## Errata: CS4340A Rev. B

(Reference CS4340A Data Sheet revision DS590PP1 dated JUN' 02)

Figure 1. SCLK to MCLK Timing

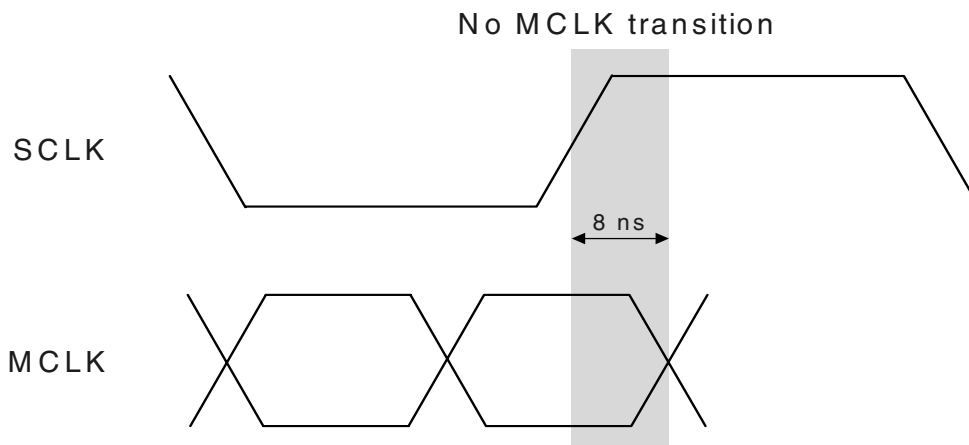
- The device does not function properly during certain phase relationships of MCLK and SCLK in Quad-Speed Mode. MCLK must not transition 0 ns to 8 ns after the rising edge of SCLK. Should a transition occur within this window, the resulting symptom will be severe distortion of the audio signal.

Note: The timing relationship is limited to a window of less than 1 ns on any individual part. However, the location of this 1 ns window across multiple devices is within the 8 ns window shown in the figure above.
